Product Change Notification / LIAL-23YFIV099

CCB 5319 Initial Notice: Qualification of MMT as a new final test site for ATWILC1000, ATWINC15x0, ATWILC3000 and ATWINC3400 device families available in 28L and 36L module package.

CCB 5319

PCN# LIAL-23YFIV099

Tray Comparison

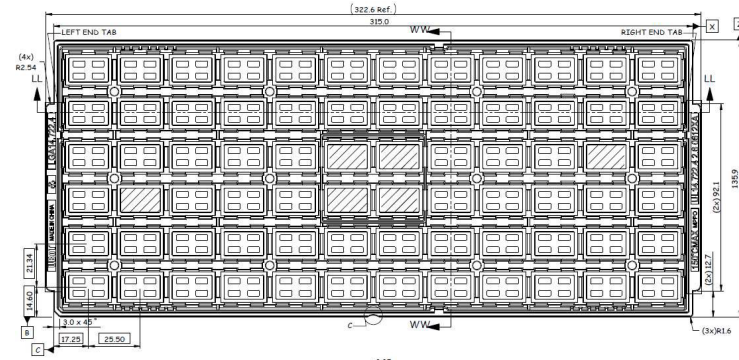
Pre Change

Media	Style	Bake?	Units per Tray	Dimensions	Color
Tray	PET Clear Tray	Not Bakeable	50	142x330mm	Transparent

Post Change

Media	Style	Bake?	Units per Tray	Dimensions	Color
Tray	Jedec Tray	Bakeable	72	135.9x322.6mm	Black
